Flight Procedure Tracking Form		Action: AMENDMENT	Task Type: SID	Date Open: 09/11/2019	Task #: 2019062427142201003	Request #: 20190624271422
Procedure: SID PEACE TWO NEW HAMPTON IA IA50			Airport ID: KIA50	Airport: MERCYONE NEW HAMPTON MEDICAL CENTER		Reimbursable #: NO
City: NEW HAMPTON	ST: IA	GPS #:	Estimated Chart Date: 01/30/2020		FICO #:	
Fac ID: N/A		Fac. Type:		Specialist: CHRISTINE BAYSE		
Procedure Review						
	Rec'd	Rel'd	Full Name	Comments		
Lead:	07/17/2019	09/11/2019	WARDELL HENNING	Digitally signed by		
QA:	09/11/2019	09/19/2019	KISSY MAXFIELD	WARDELL HENNING		
Liaison:				Oct 28, 2019		
Procedure Comments: ENROUTE Remark Type: INFORMATION SPECIAL PROCEDURE. ABBREVIATED AMENDMENT. PENDING AIRPORT AIRNAV DATA USED DATED 1/30/2020. PROCESSED IAW AIRCRAFT OPERATIONS GROUP (AJW-33) MEMO, OCTOBER 3, 2018, SUBJET: FLIGHT INSPECTION REVIEW NOT REQUIRED. CONTACT: GEORGE DAVIS 405-954-9960 OR WARDELL HENNING 405-954-9954 10/22/19: THIS IS AN UPDATED COPY OF THE FORM DEVELOPED ON 08/07/19. 1. UPDATED FIX FROM ZUKEN TO ZUKEL IN DP ROUTE DESCRIPTION.

3. Special: (IA50) MERCYONE MEDICAL CENTER, NEW HAMPTON, IA - COPTER PEACE (RNAV) TWO DEPARTURE

PRB Result: RETURN FOR REWORK

DEPARTURE ROUTE DESCRIPTION

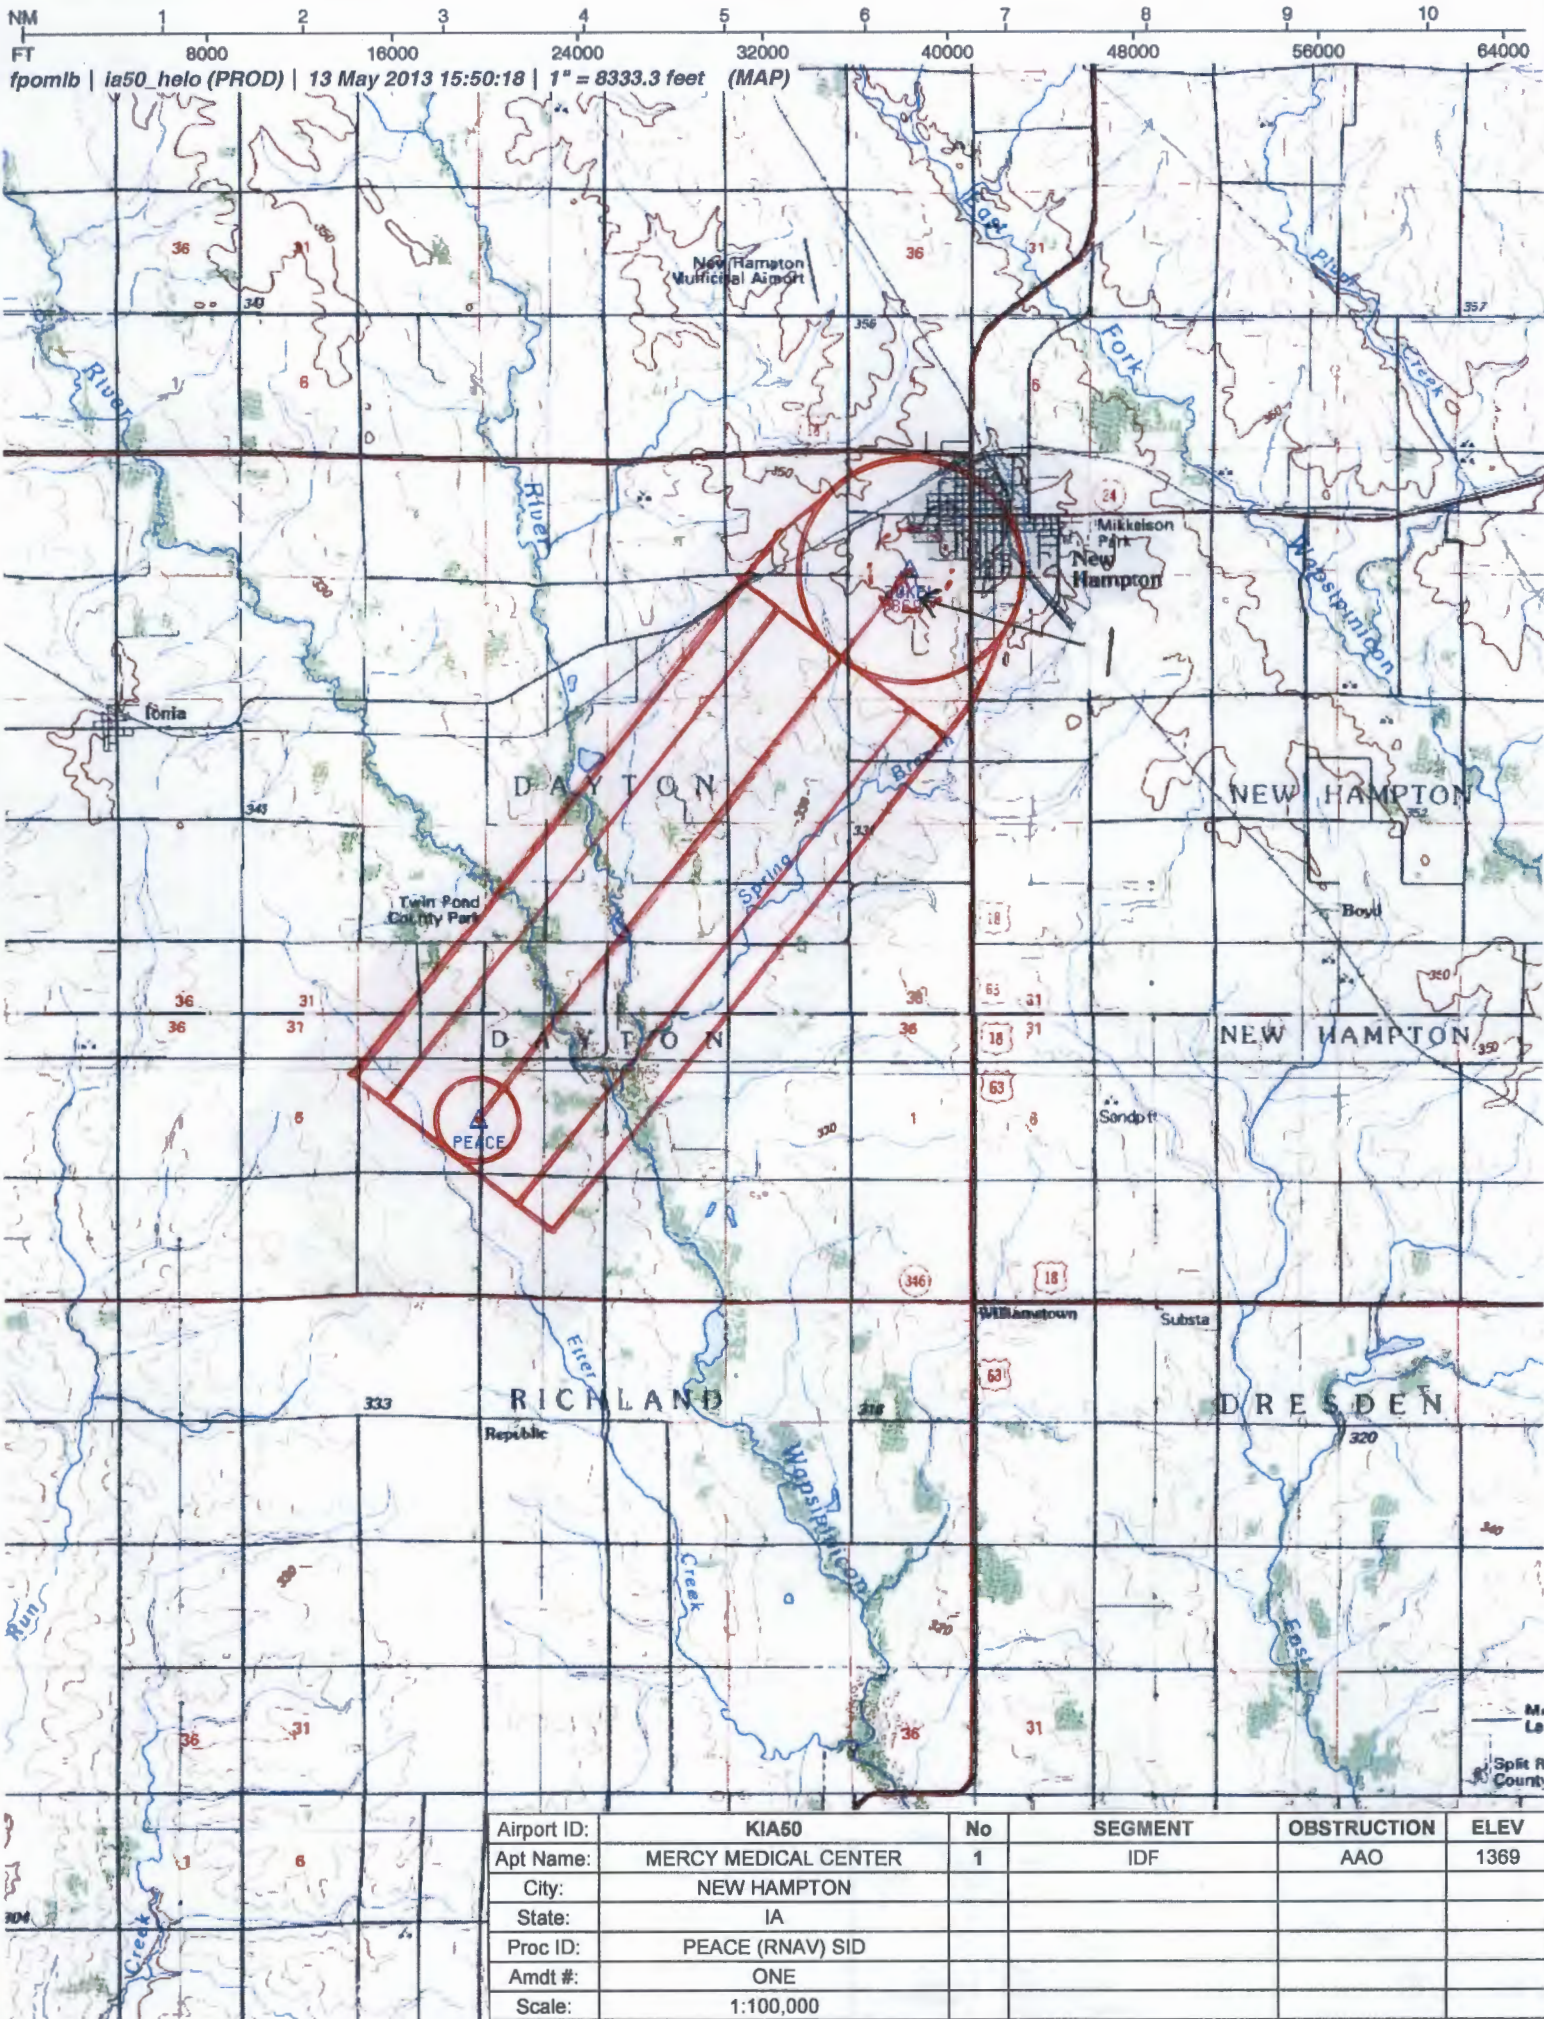
- a. Correct typographical error on Form 8260-15B. Change "VFR SEGMENT: VFR CLIMB TO ZUKEL, CROSS ZUKEN AT OR ABOVE 1700" to "VFR SEGMENT: VFR CLIMB TO ZUKEL, CROSS ZUKEL AT OR ABOVE 1700."
- b. Add Maps with identifying scale, graphically depicting obstacles in relation to the obstacle evaluation areas (OEAs) per 8260.60, paragraph 2-1-4a(2).
- c. Add graphic portrayal of the procedure per 8260.60, paragraph 2-1-4a(9).

VFR SEGMENT: VFR climb to ZUKEL, cross ZUKEL at or above 1700.
IFR SEGMENT: On track 218° to cross PEACE at or above 3000.
